**VILLAGE OF JACKSON
PLAN COMMISSION MEETING AGENDA**

Subject: Conditional Use Request and Site Plan Review - Cedar Creek Townhomes, LLC, for Parcel: V3_019700V - James Kupfer

The developer has submitted a revised development proposal for the above referenced 3.955-acre parcel which includes the construction of 36-apartment units. This item was previously tables at the June 20, 2024 meeting. A preliminary concept plan was submitted and reviewed by the Plan Commission on April 20, 2023. A conditional use and site plan review was recommended to the Village Board for approval on November 14, 2023, along with a review of a draft Development Agreement. The Village Board also subsequently approved the conditional use, site plan and Development Agreement at their meeting that same evening.

PLAN TITLE:
**PROPOSED
SITE PLAN**

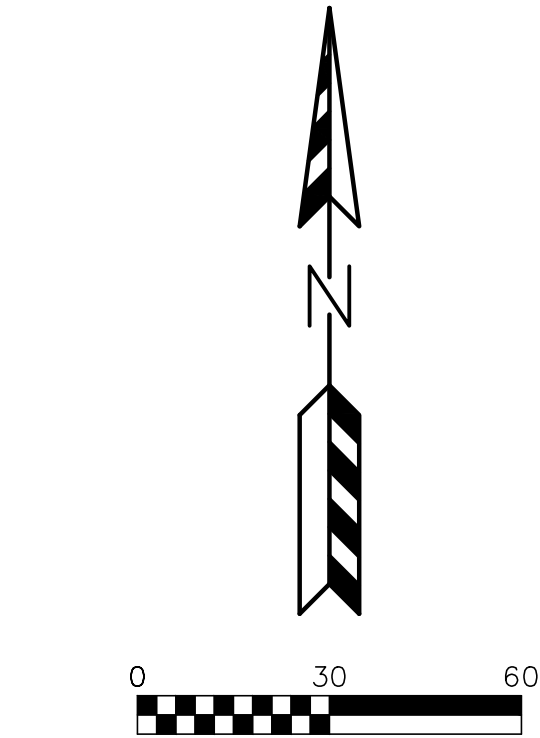
- East/West sidewalk detailed in the overall site plan should be relocated to the south of the adjacent parking stalls to ensure a fully accessible route.

SANITARY MANHOLE DETAIL

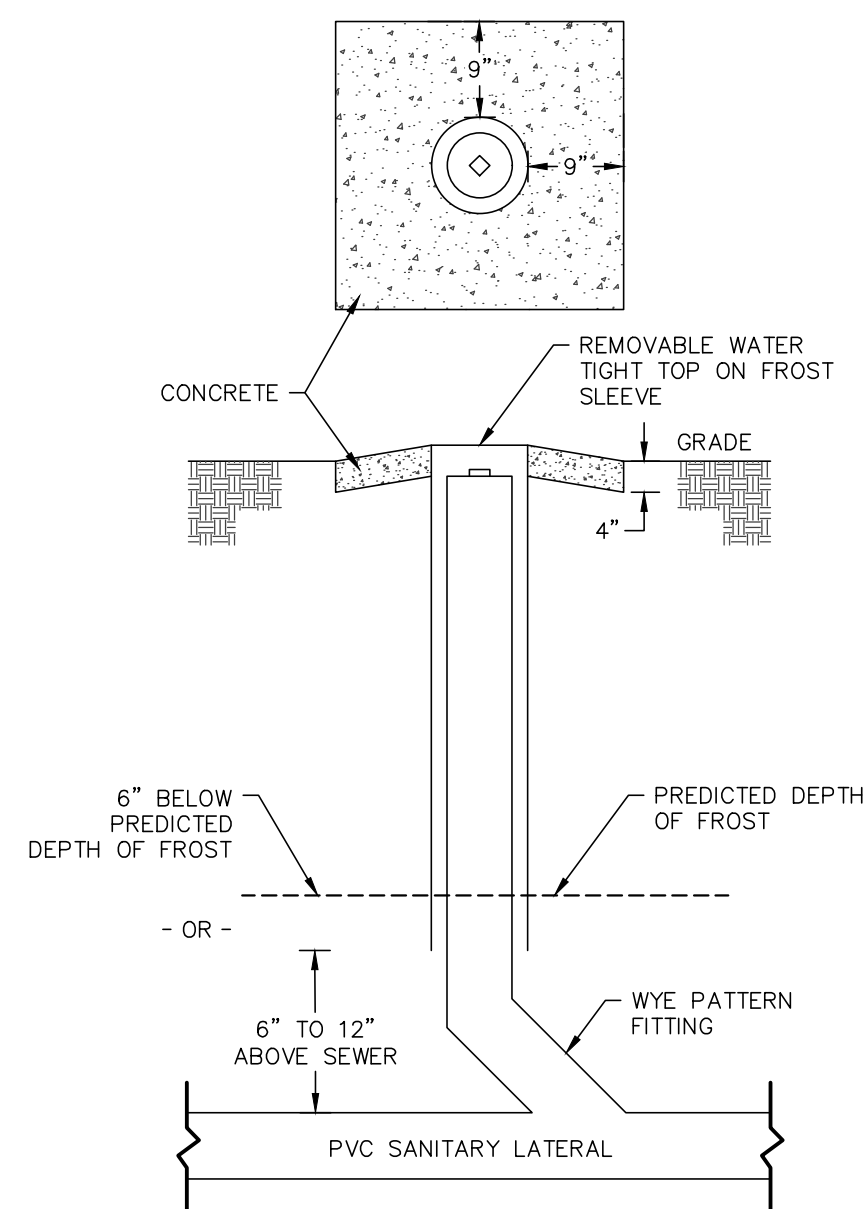
- Sanitary sewer laterals shall discharge directly into the sewer main and not in the manhole.
- Sanitary manholes shall be per Village standard detail B-3. See attached detail.
